**SUBDIVISION,  
PLANNED UNIT DEVELOPMENT, &  
REZONING STAFF REPORT****Date: September 21, 2017****APPLICANT NAME**

Ascension Subdivision

Subdivision Approval to relocate the interior lot line between two legal lots of record; Planned Unit Development to allow multiple buildings on a single building site; and Rezoning from R-1, Single-Family Residential District and B-3, Community Business District to B-3, Community Business District to eliminate split zoning and allow construction of a funeral chapel.

# SITE PLAN

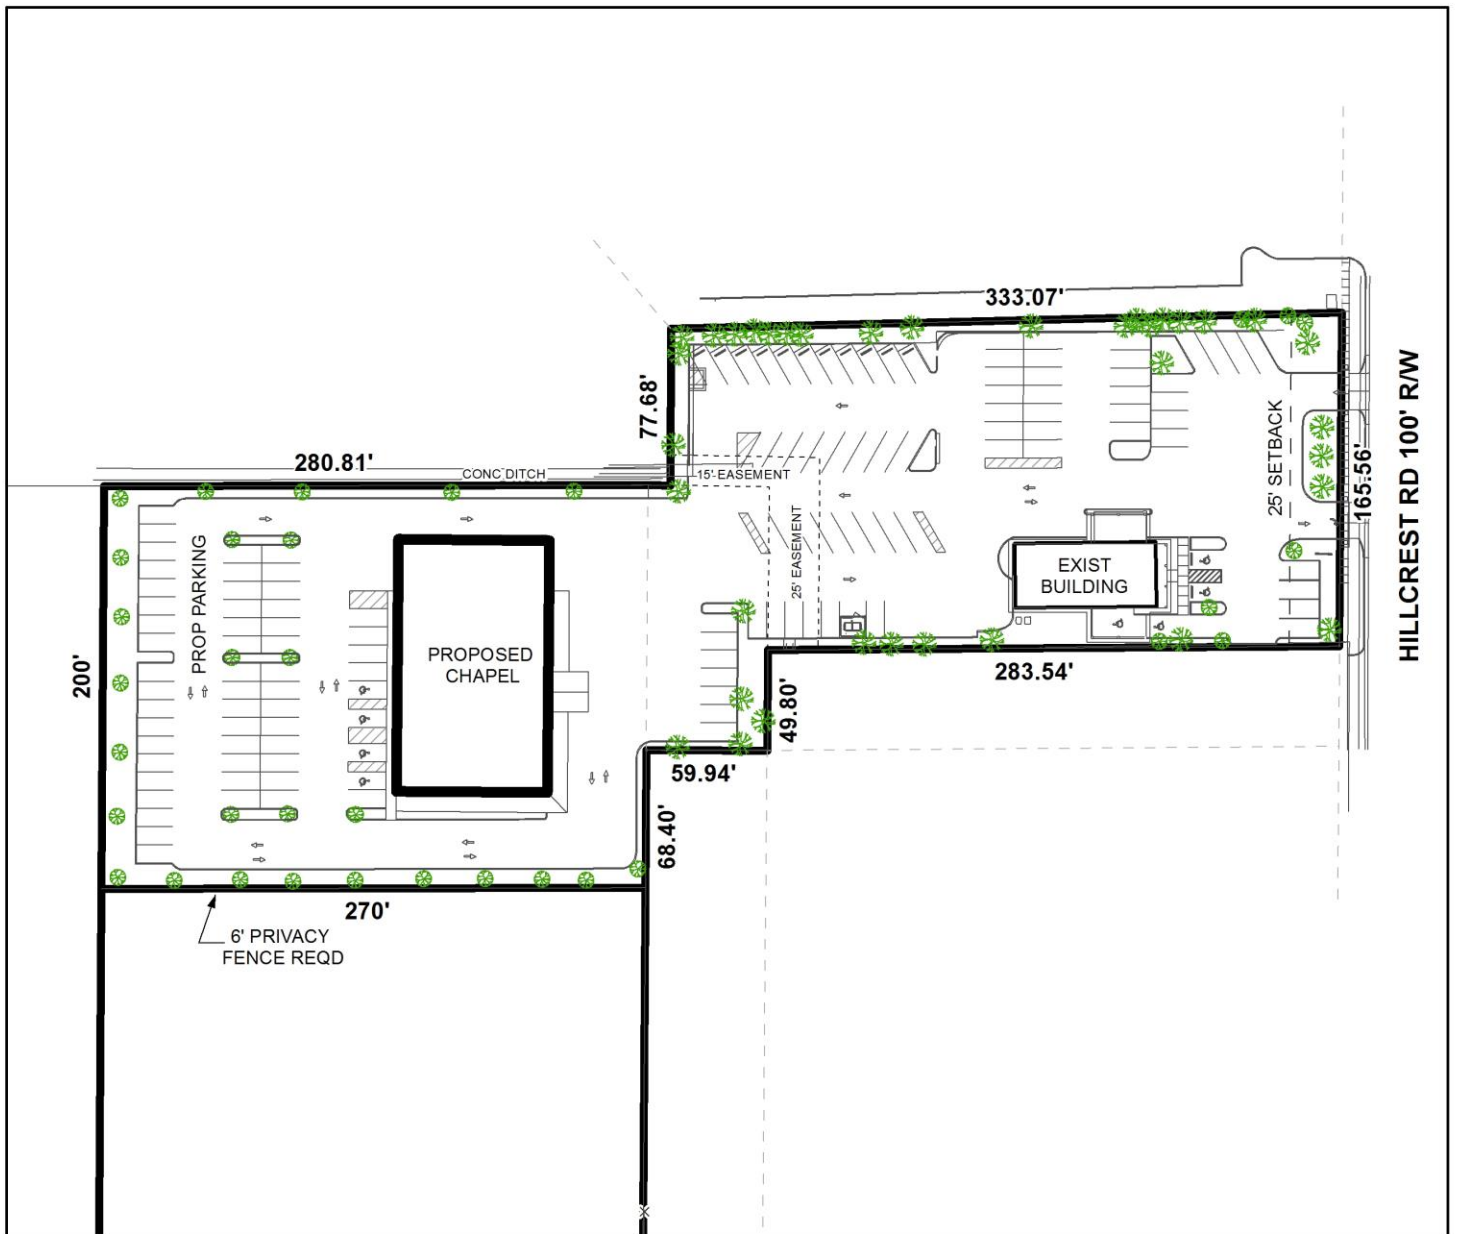
The proposed lots, as depicted, meet the minimum size and frontage requirements as regulated by the Subdivision Regulations. The lot area sizes are depicted on the plat in square feet and acres. The 25-foot minimum building setback line is depicted along Hillcrest Road, with a 35-foot minimum building setback line depicted along Johnston Lane, both as depicted on previously recorded subdivision plats. If approved, at least a 25-foot minimum building setback should be illustrated along both frontages.

It should be noted that there is a drainage and utility easement on the proposed Lot A. If approved, a note should be placed on the Final Plat stating that no structures will be placed in any easement.

It appears that an existing dumpster is illustrated on the site plan, but is not labeled as such. If approved, the dumpster should be labeled.

The proposed Lot A to be rezoned is adjacent to R-1, Single-Family Residential properties to the South and West. The site plan should be revised to illustrate a 6' high wooden privacy fence next to all adjacent R-1, Single-Family Residential District properties.

*The applicant has revised the site plan to indicate that there will be 200 seats in the chapel, as well as labelled the existing enclosed dumpster. There is also a note indicating that a 6' privacy fence is required along the property lines abut R-1, Single-Family Residential property. The applicant is requesting that the construction of the required fence be postponed until such time as the adjacent property is developed residentially, as they are heavily wooded at this time. While the Planning Commission may consider this request, it is important to note that granting it may cause an enforcement issue for staff later on.*

# DETAIL SITE PLAN

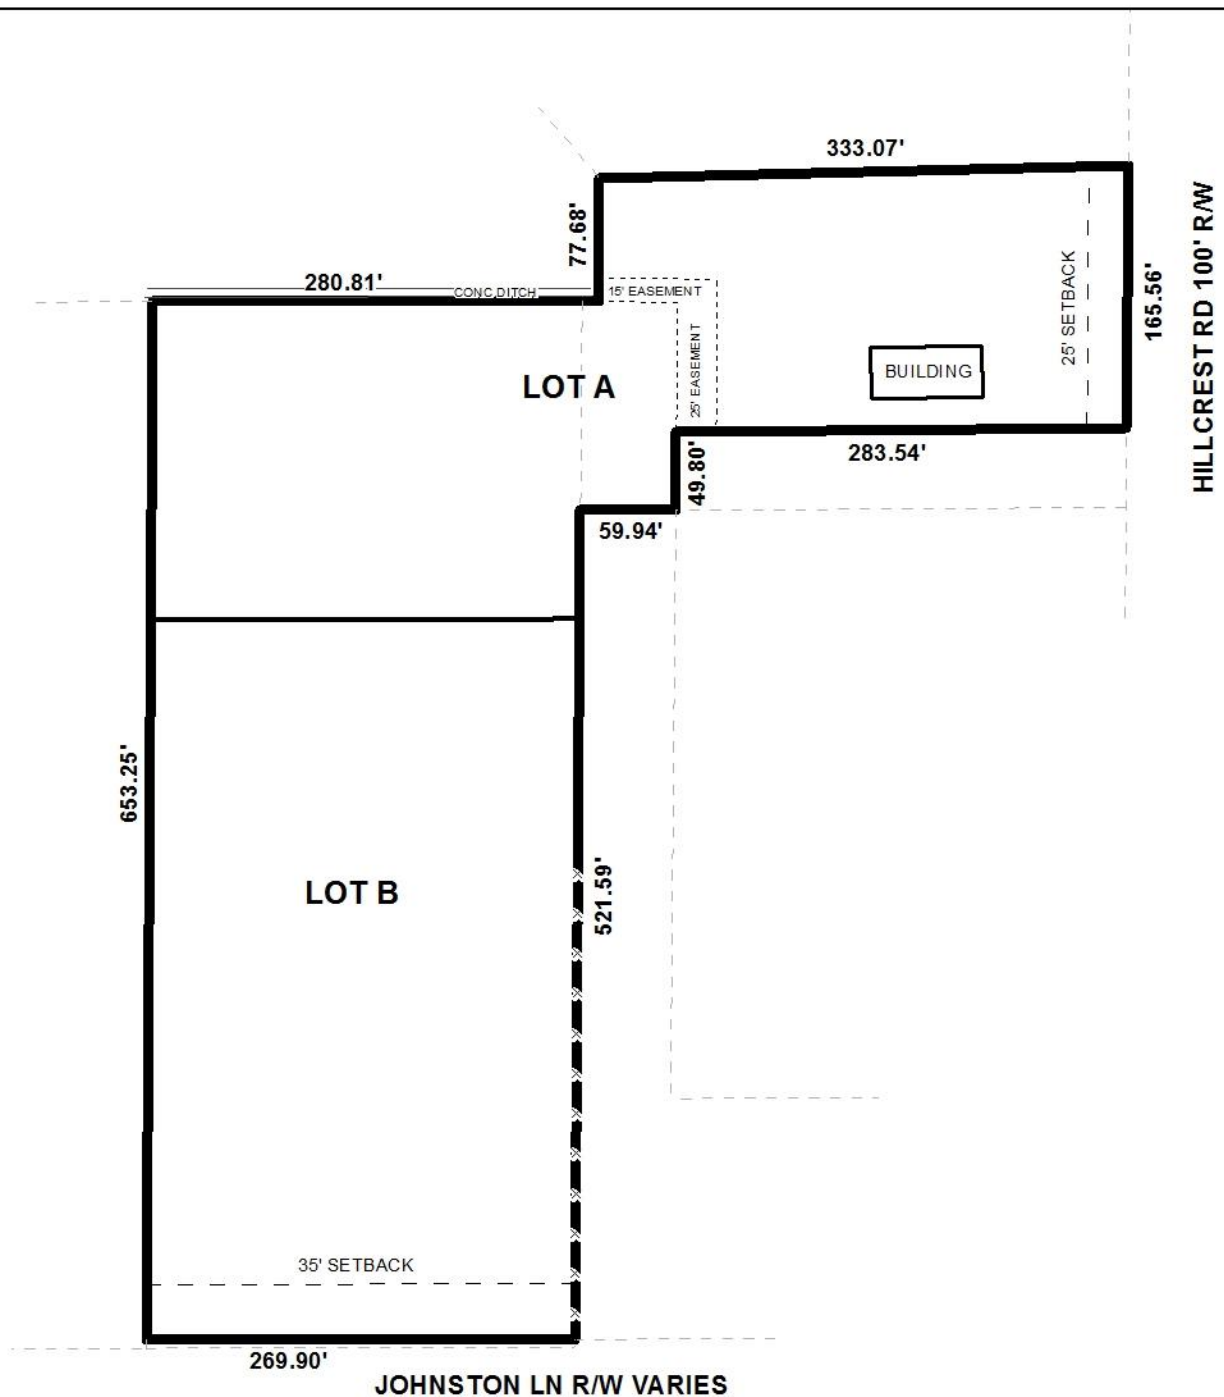
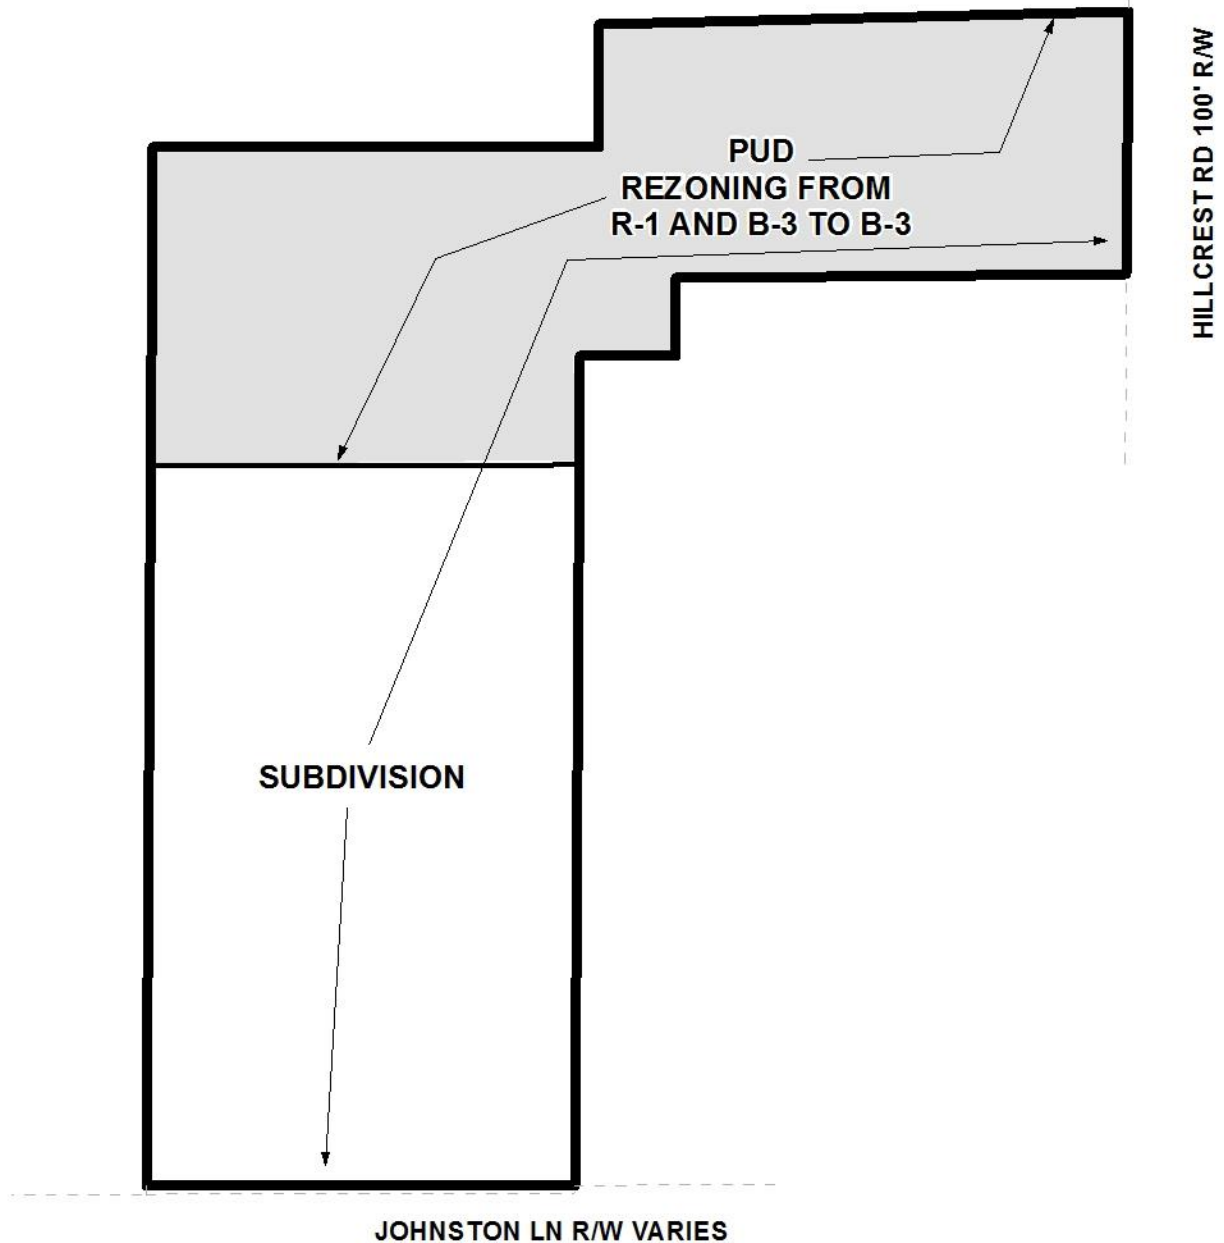
The site plan submitted only provides tree planting and landscape area information on the proposed addition to the lot, and does not include the existing developed portion. It should be noted that there is a tree plan on file for the existing development, however expanding the size of Lot A dramatically increases the amount of front landscape area required, from 4,175 square feet to 8,063 square feet. No information has been provided to indicate compliance, and as such, it should be insured that the entire site will be compliant with tree planting and landscape area prior to approval.

It should be noted that the proposed chapel will have 200 seats, making 50 parking spaces required, and 56 new parking spaces are proposed, in addition to the 74 existing parking spaces, for a total of 130 parking spaces, which exceed the required parking minimum of 63 parking spaces. It should be noted the proposed parking will be an increase exceeding 25%; therefore a photometric site plan will be required at the time of permitting.

*Finally, the site plan has been revised to indicate tree planting and landscape area calculations for the entire site. Based on the information provided, the site will exceed the minimum amount of landscaped area by more than 5,000 square feet, while being short on the amount of front landscaped area required by less than 4,000 square feet. While the Zoning Ordinance requires front landscape area to be located between the front property line and the building, the Planning Commission does have the authority to allow landscaped areas on other portions of the site to fulfil this requirement.*
